**Planning Commission Agenda
Regular Meeting
Tuesday, November 1, 2016
6:00 P.M.**

**DAVE’S EARTHWORKS, INC. SITE PLAN & SPECIAL USE PERMIT
STAFF REPORT
SPR2016-001 & SUP2016-002**

Project Name: Dave’s Earthworks, Inc. Site Plan & Special Use Permit

DATE	8.31.16
REVISIONS	
SHEET TITLE	Site Plan Map
SHEET NUMBER	SP2

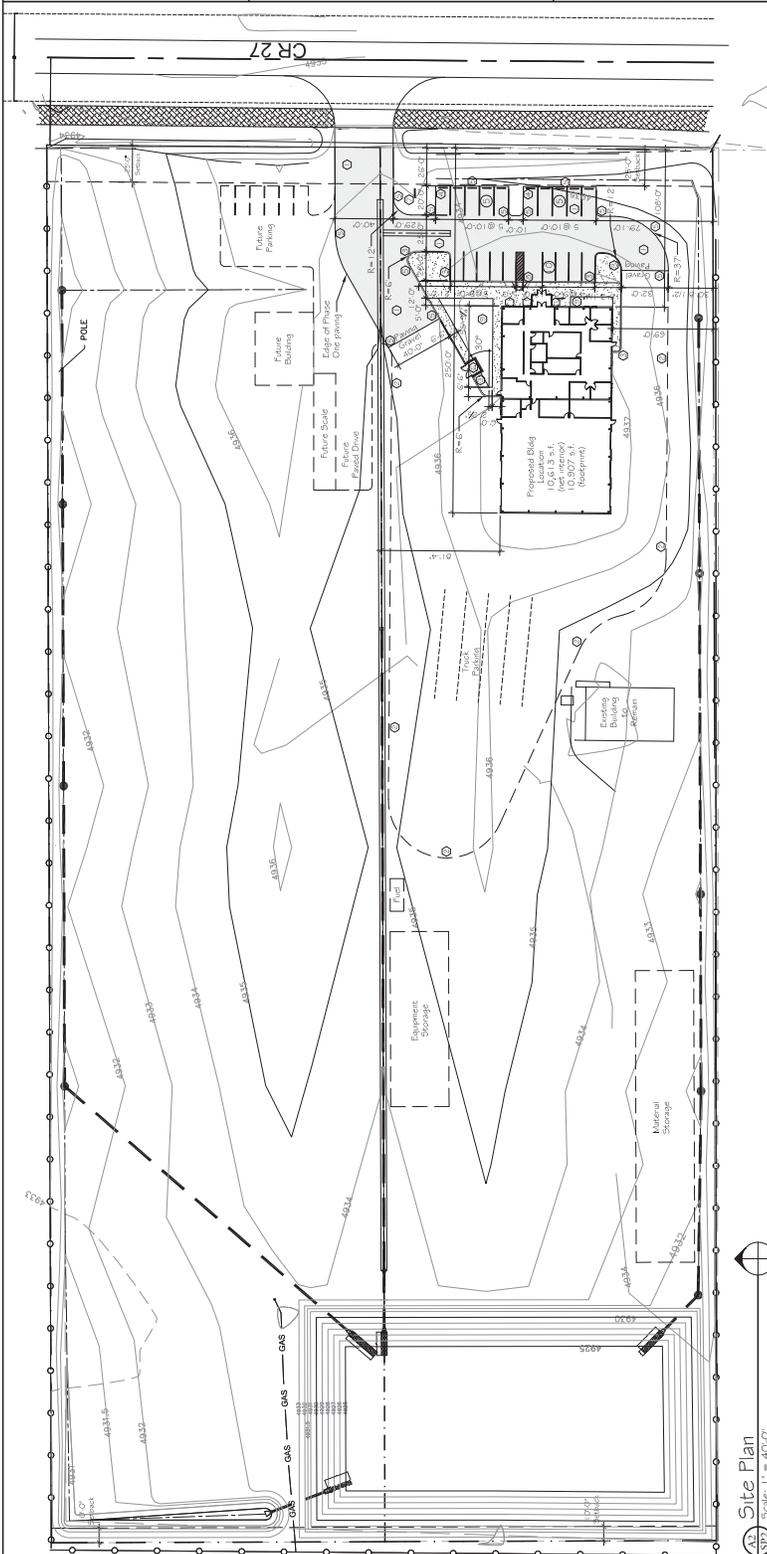
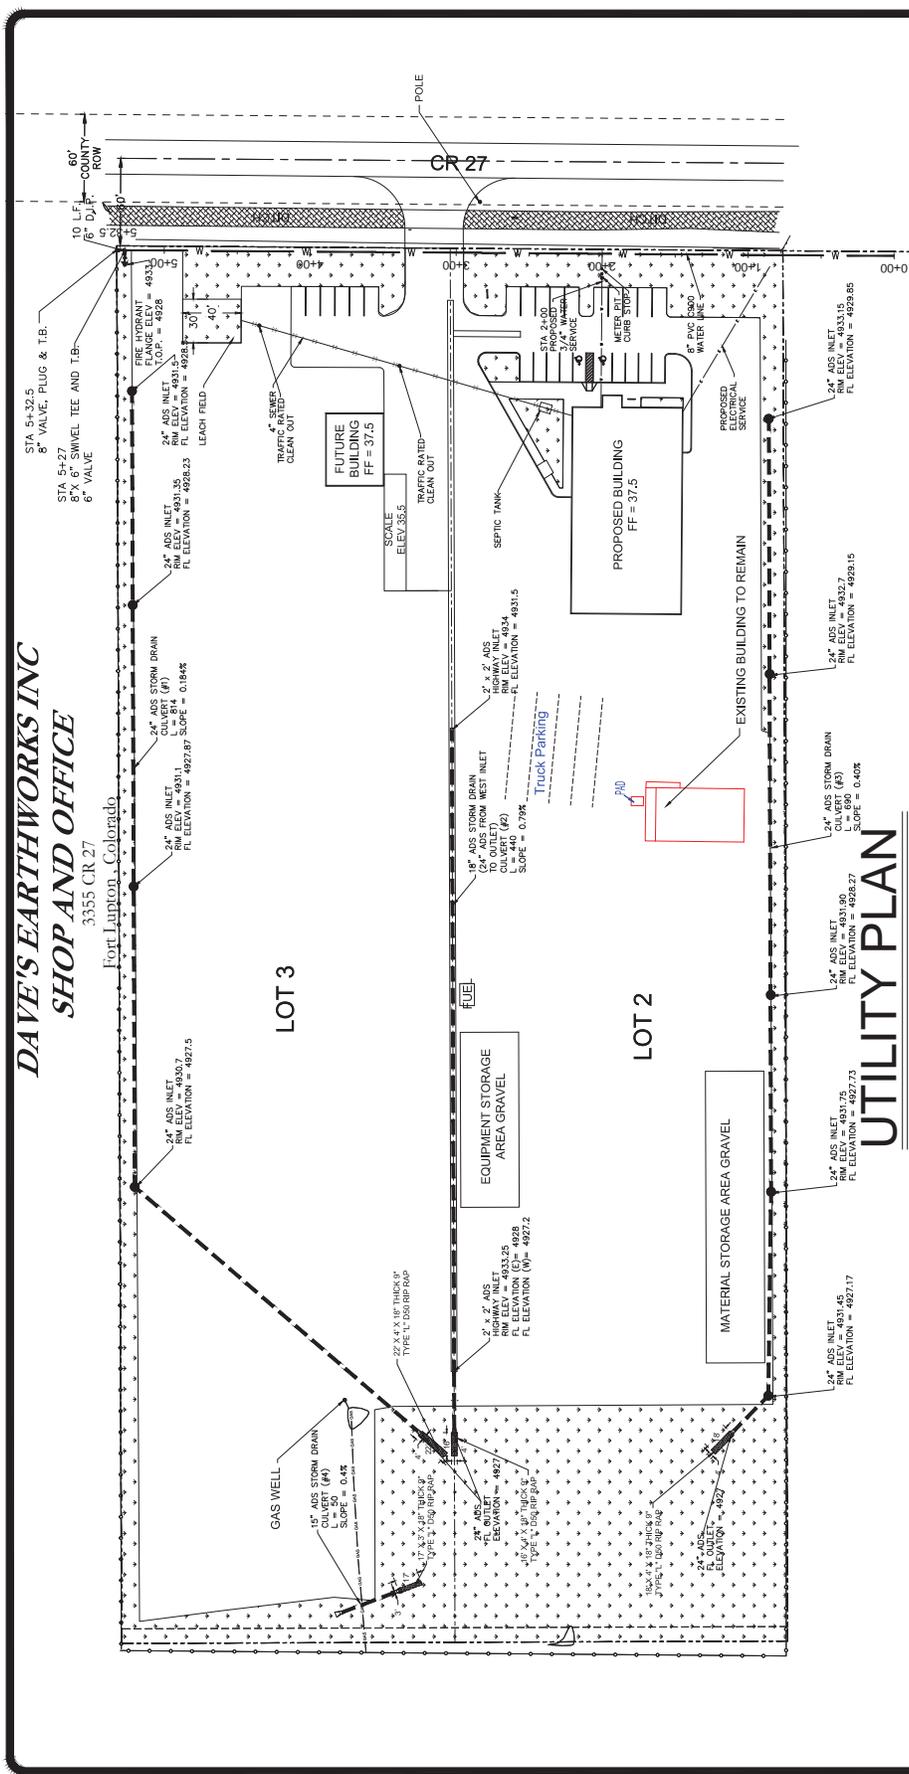
1. A dedicated emergency access road 20' in width shall be delineated on the plans. The emergency access road shall extend to within 150' of all portions of the exterior walls of the first story of the buildings as measured by an approved route around the exterior of the building and fuel tank area (See Sheet SP2 for comments). *2012 IFC 503.1.1*
2. Fire Flow Requirements:

DATE: 08/26/09
PROJECT # 09-001
SHEET 1 OF 4
C3

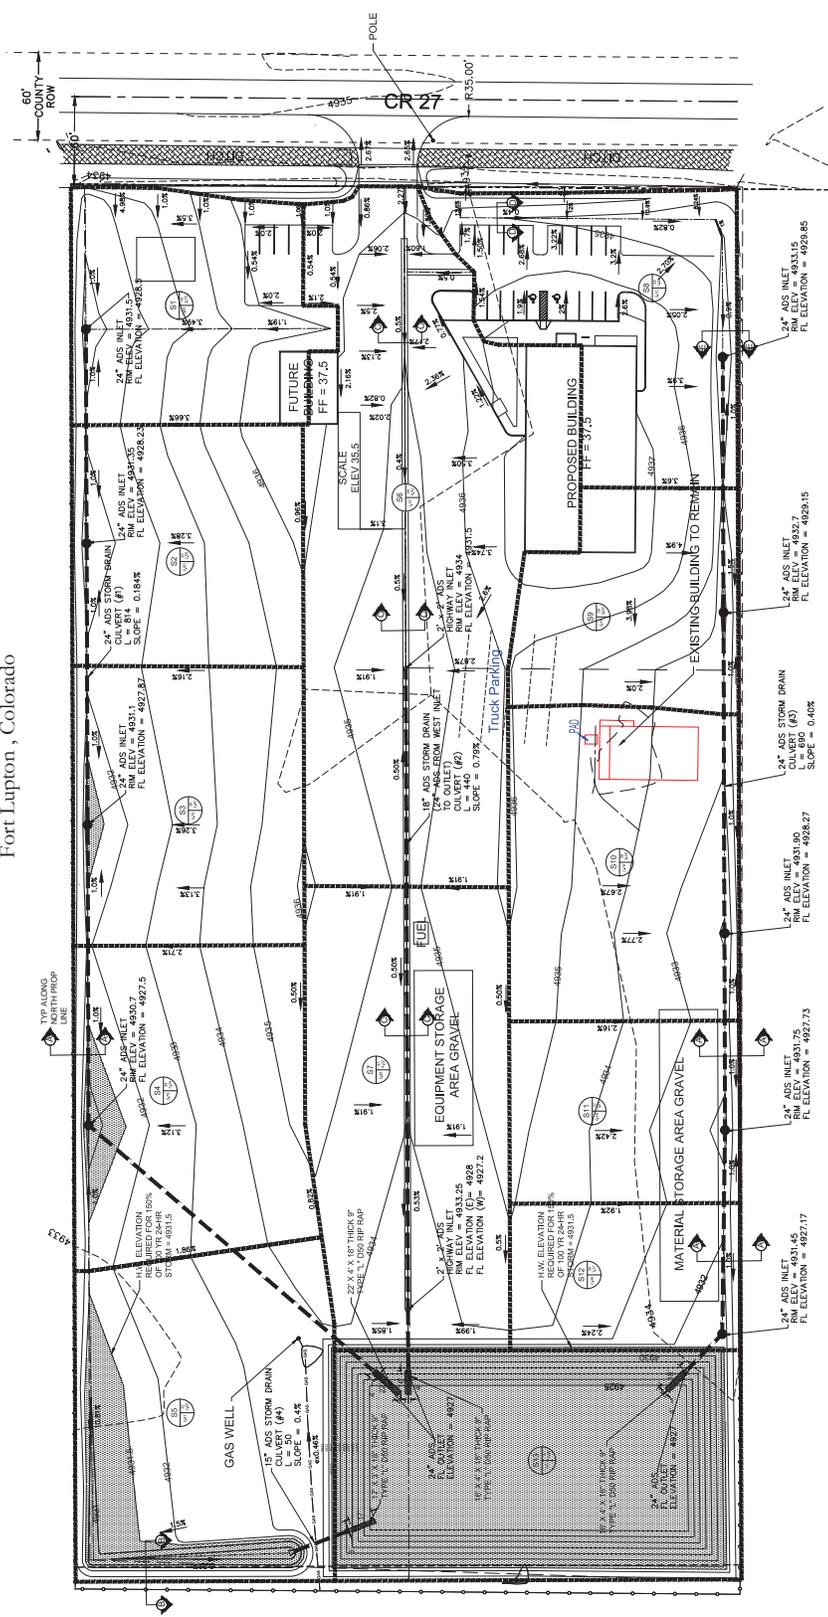
- c. Sheet C3 – Future Building pad FF elevation would require lowering the proposed grading and may create a sump condition at time of implementation. Should consider minimum FF of 38.5.
